AMERICAN TELECOMMUNICATION CORPORATION
KIT FOR CUSTOM TELEPHONE
INSTALLATION AND MAINTENANCE

1.01 This addendum is issued to provide the procedures for modifying Decorator Telephone Conversion Kit A-4200 for use with key telephone systems.

Figure 5. Wiring Diagram of Decorator Conversion Kit Wired for Use in Key Telephone System.

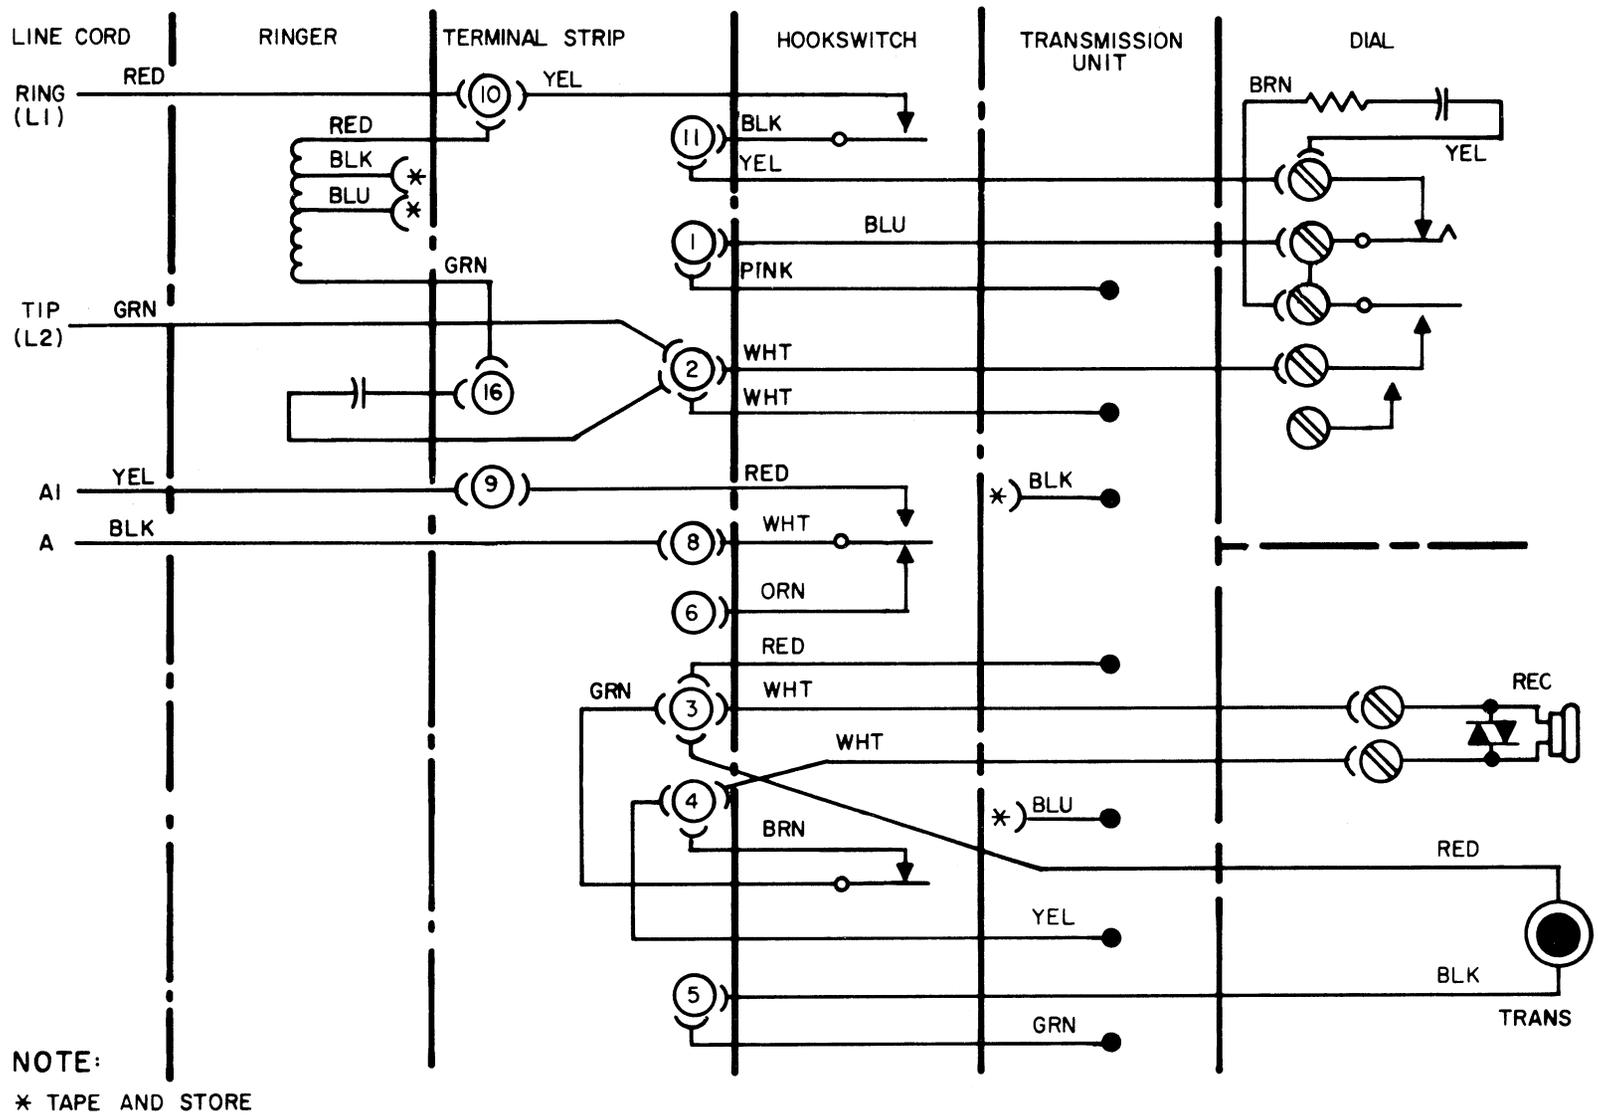
2.01 Add Part 5 and Figure 5 as follows:

5.01 To modify the conversion kit for use in key telephone systems, proceed as follows (Figure 5):

- (1) Remove the three-conductor line cord and replace with a four- or six-conductor line cord.
- (2) Connect the line cord to the terminals in the base as follows:
 - (a) RED (Ring) to terminal 10.
 - (b) GRN (Tip) to terminal 2.
 - (c) BLK (A) to terminal 8.
 - (d) YEL (A1) to terminal 9.
- (3) Move the ringer capacitor lead from terminal 9 to terminal 2.
- (4) Move the RED hookswitch lead from terminal 2 to terminal 9.
